R E M A R K S

Objection to Drawings

Rejection of Claims under 35 U.S.C. §112:

Prior Art Rejections

Fig.1

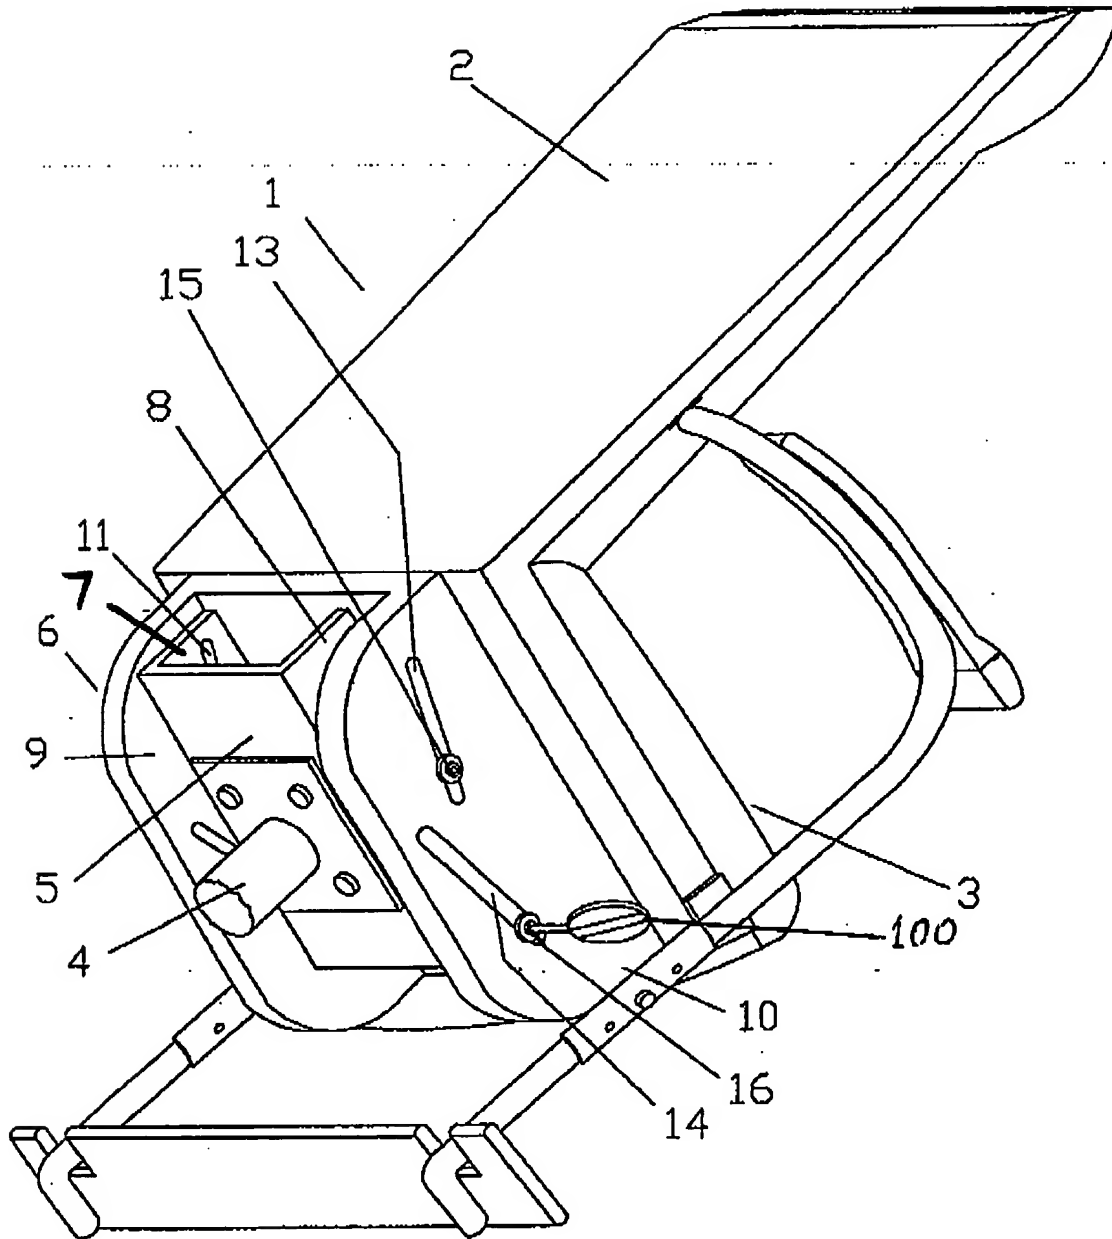
The drawings were objected to as not showing every feature of the invention specified in the claims.

It was stated that the features of "the support tray, lever, ground surface, motor and arrangement," as recited in the claims, must be shown in the drawings, or must be canceled from the claims.

In addition, Fig. 1 was objected to on the ground that element 16 appears to have another element extending from it, and it is unclear what this element is. Element 16 is the shaft in slot 14. See page 2, lines 22-24. There is no element extending from shaft 16 in Fig. 1. It is submitted that the confusion arose because the lead line for shaft 16 was not extended sufficiently far, and therefore ended at the end of slot 14, rather than continuing the small distance to shaft 16.

The lever of claim 9 is shown in Figs. 1 and 5, and has been labeled in Figs. 1 and 5 by numeral 100. The specification has been amended at page 3, line 23.

In this regard, the lead line for element 16 has been extended to point to shaft 16, rather than the end of slot 14.

The enclosed Replacement Sheet and an Annotated Sheet Showing Changes to Fig. 1 also make this change.
